DANVILLE
RIVER DISTRICT DESIGN COMMISSION

AUGUST 11, 2016
4:00 P.M.
CITY COUNCIL CONFERENCE ROOM
AGENDA

MEETING OF AUGUST 11, 2016

521 Loyal St

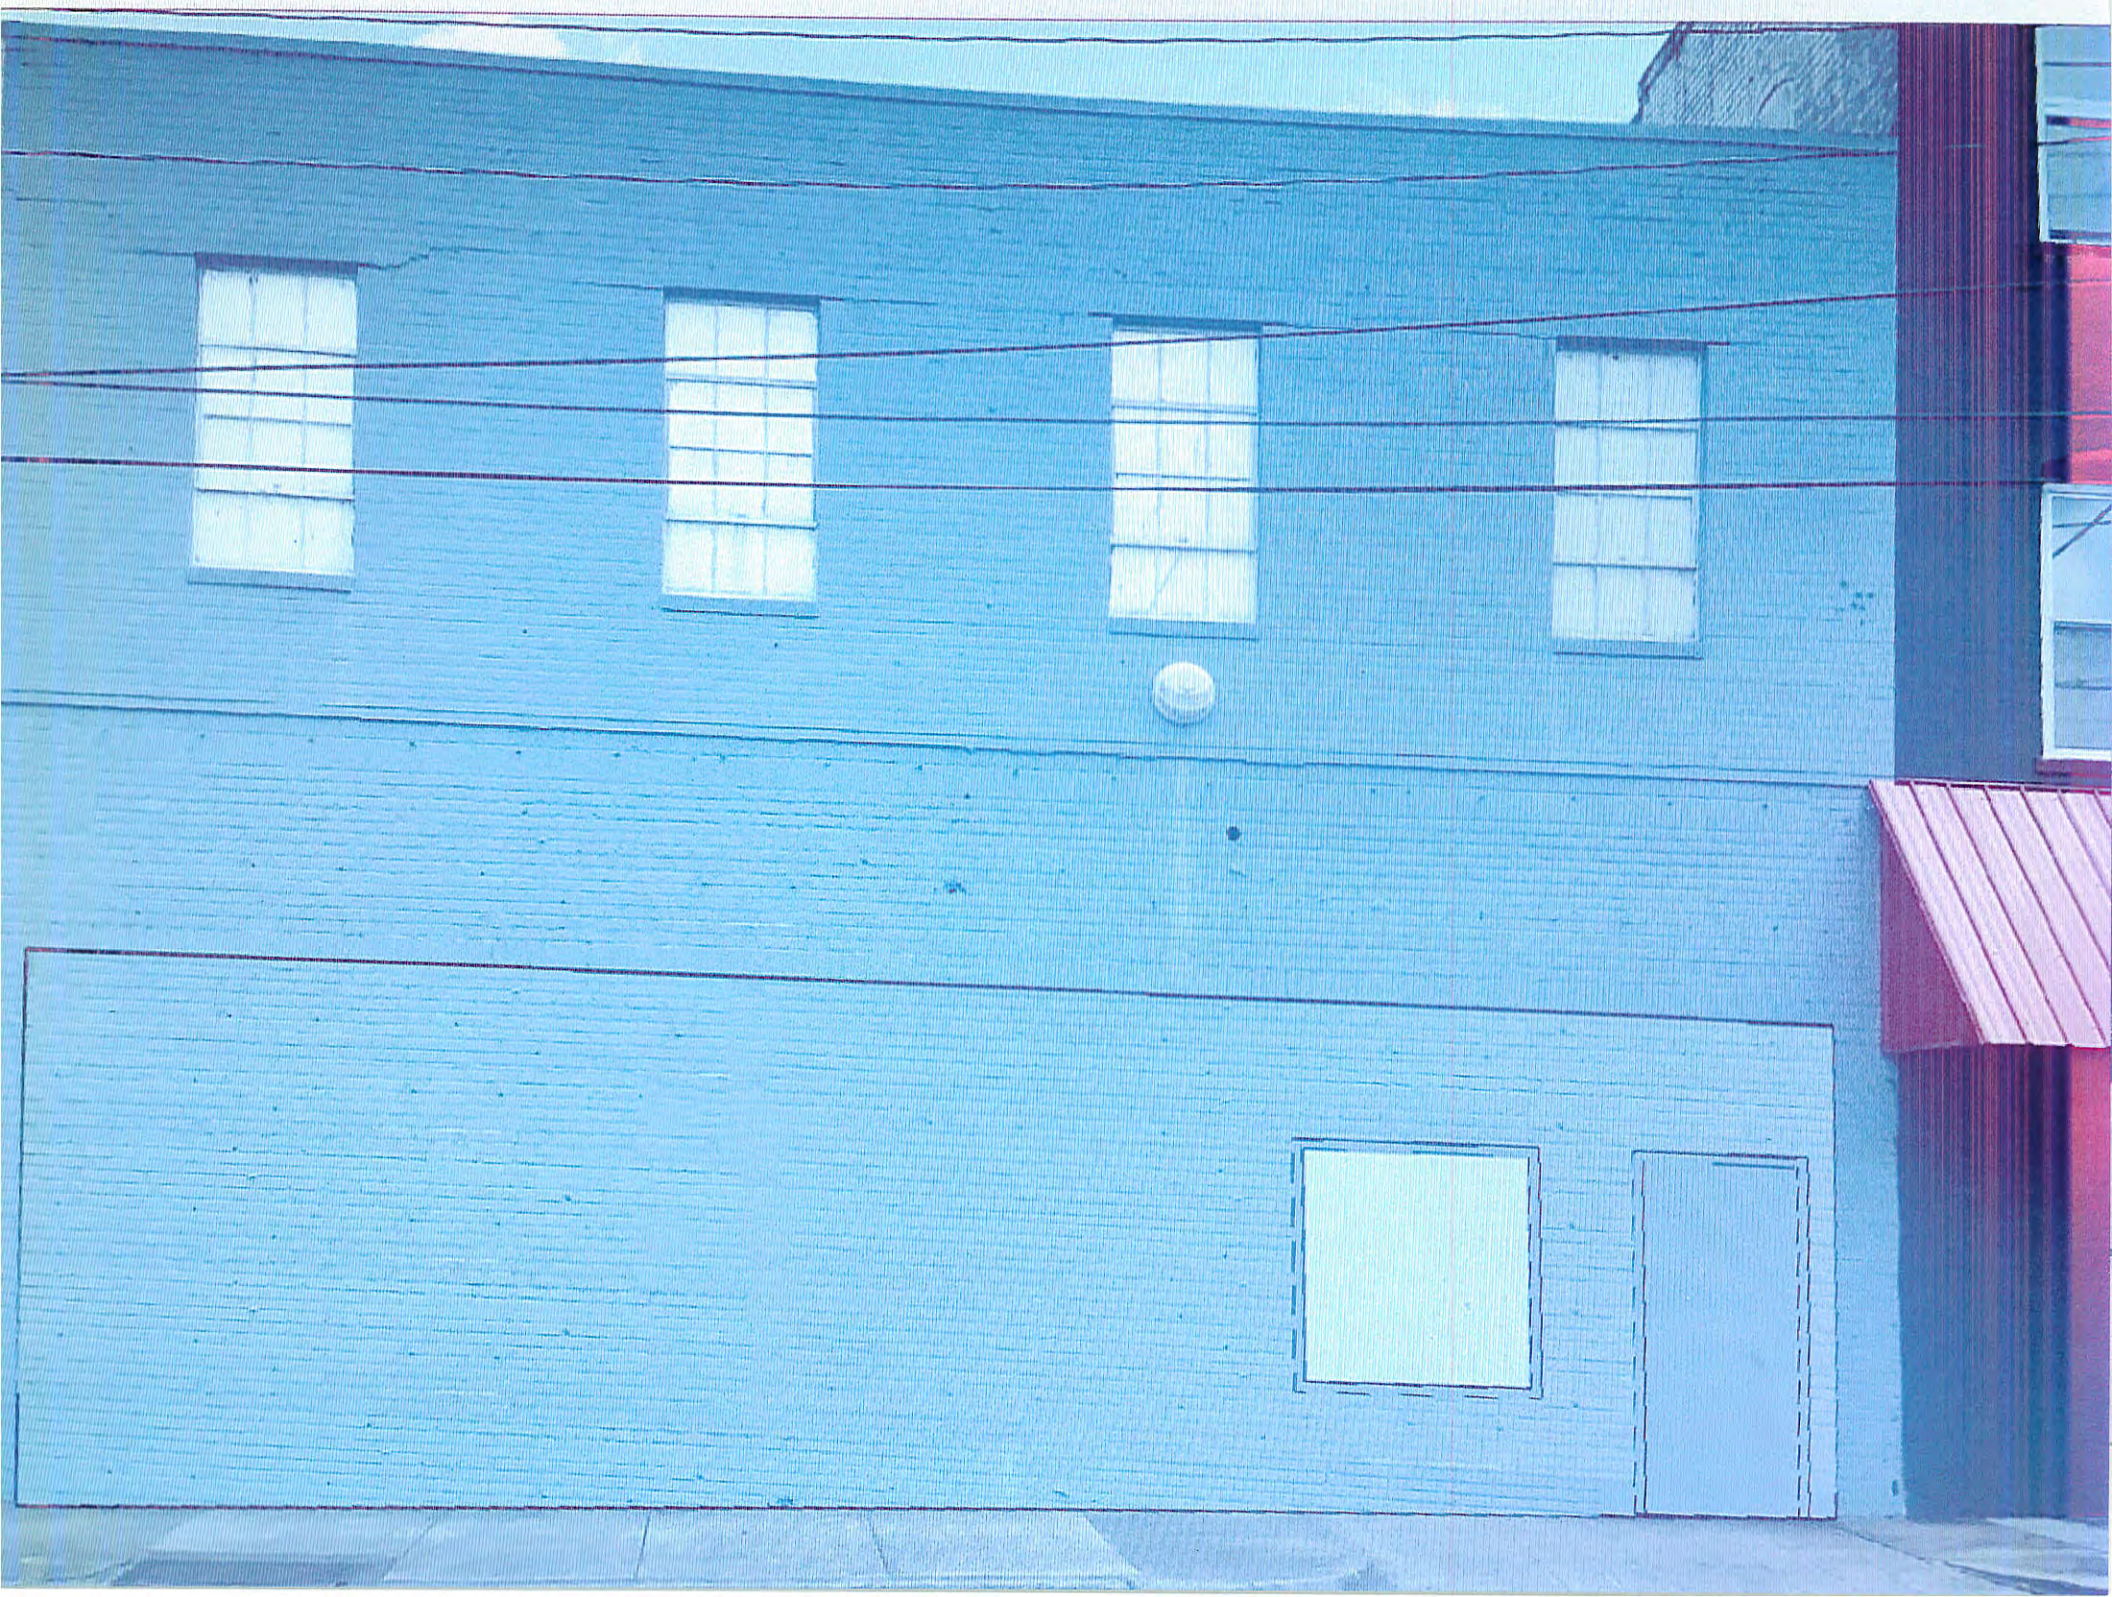
Staff recommends approval of the request for a Certificate of Appropriateness at 521 Loyal St to alter the existing storefront by removing the particle board façade with artificial windows and installing a brick and block storefront. Whereas the faux façade was made out of materials that did not match the original materials, staff believes that the proposed alteration will match the original materials and will be in compliance with the guidelines. The existing brick is painted blue so painting the new brick will comply with the guidelines.

BROKEN GLASS
IN OLD METAL
FRAME

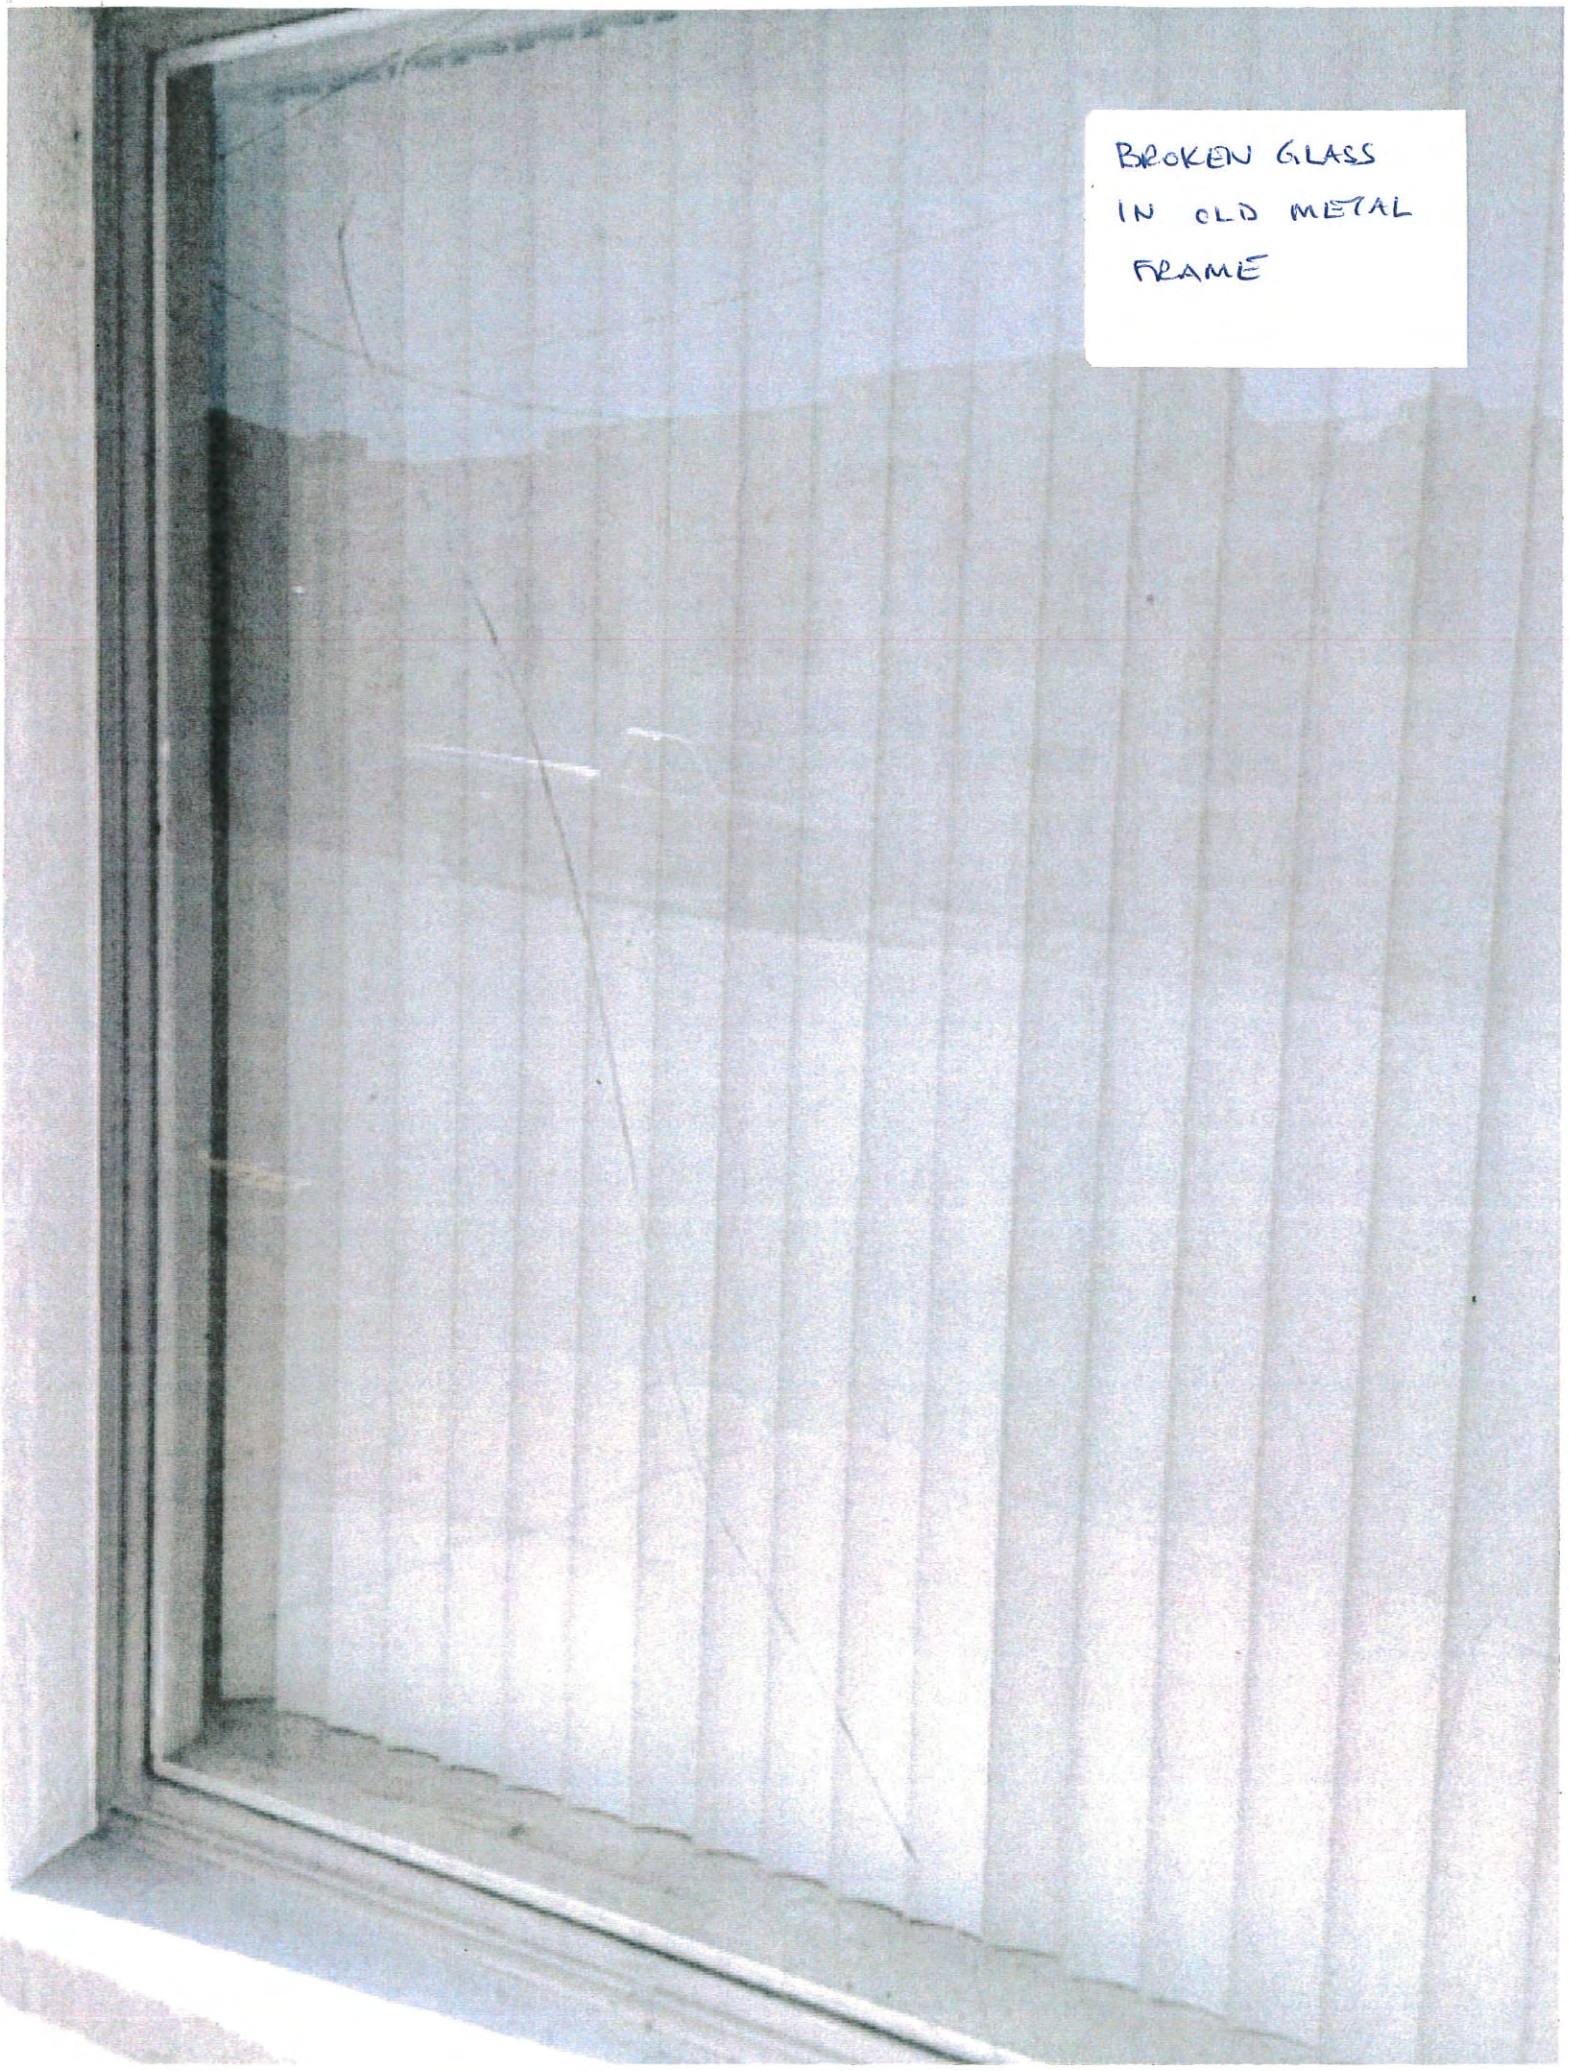
Staff recommends approval of the request for a Certificate of Appropriateness at 523 Loyal St to replace a broken plate glass window in an old metal frame with a new tempered glass window and new metal frame. The original door and window at the entrance has already been replaced with tempered glass and new metal framing so the proposed replacement would be consistent with what is already in place.

762
NO PARKING

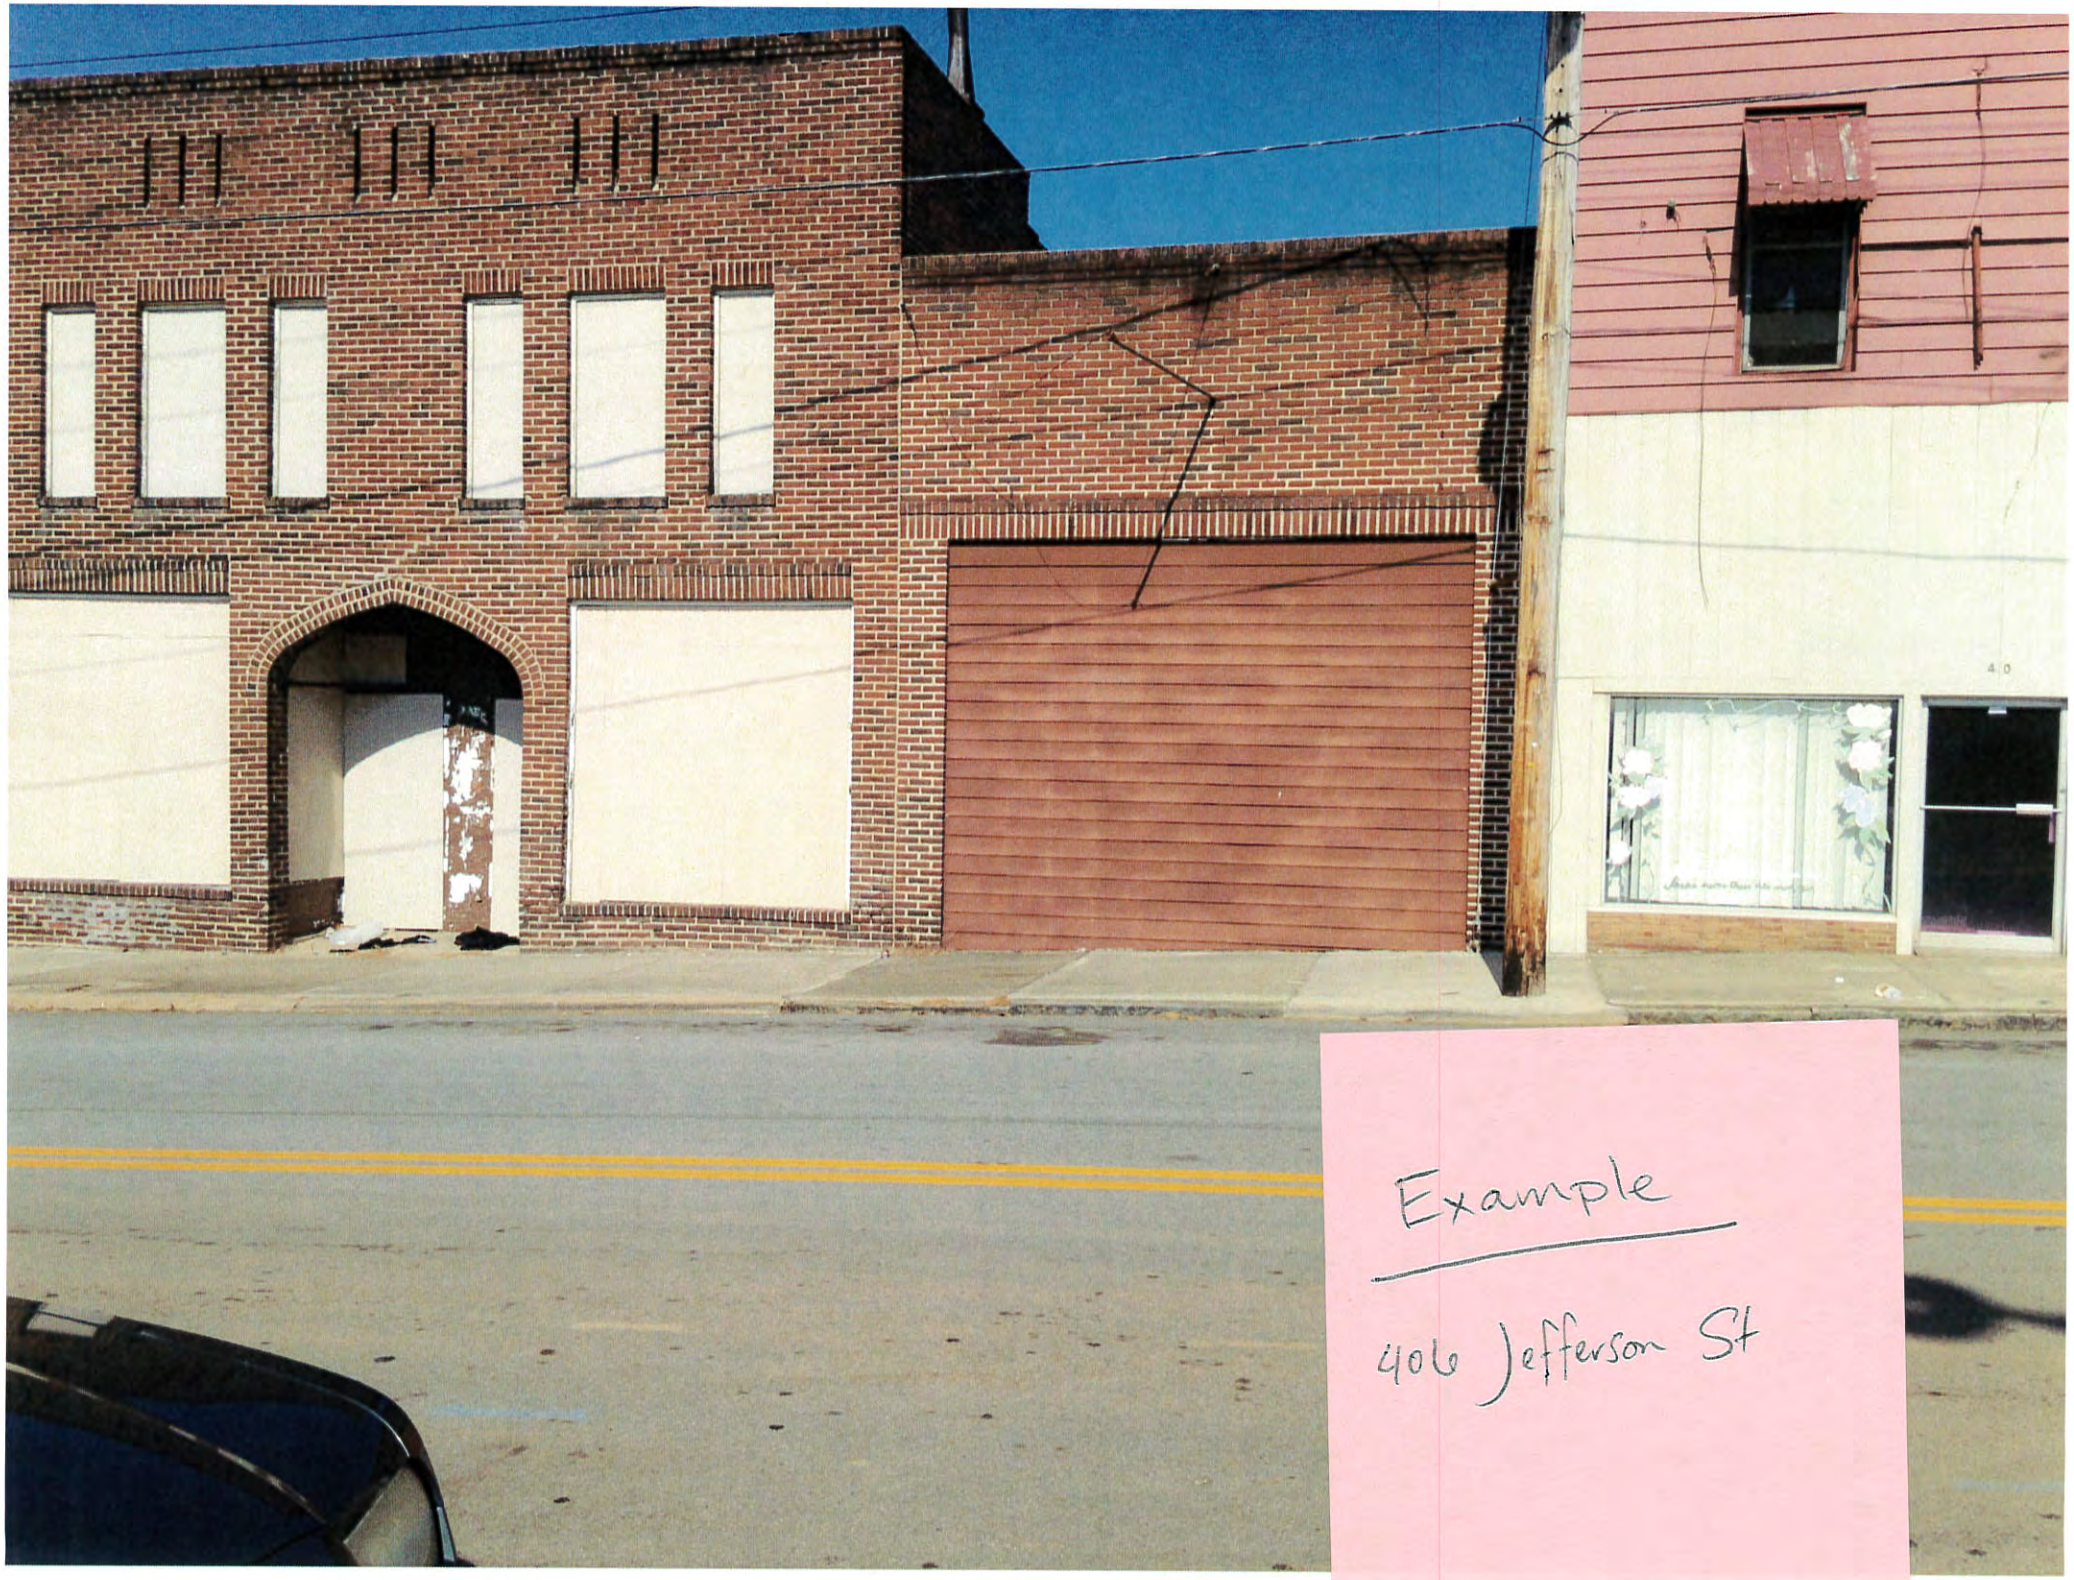
Staff does not recommend removal of any of the stained glass because staff believes the stained glass windows contribute to the historic character of the building. The River District Guidelines do not specifically recommend or prohibit hardie plank, however it is a specifically recommended material in the Old West End Guidelines.

If the River District Commission believes that hardie plank is an acceptable material, Staff recommends approval of the request for Certificate of Appropriateness to replace non-stained glass broken windows with harkie plank. Staff recommends approval with the condition that the hardie plank be painted a brick red color so that it matches the rest of the brick building. Staff recommends limiting the time that the hardie plank may be in place to a period of one (1) year.

Staff recommends approval of the request for a Certificate of Appropriateness at 762 Loyal Street to install a new garage door, repair and paint the metal soffit, and to replace the entrance door.
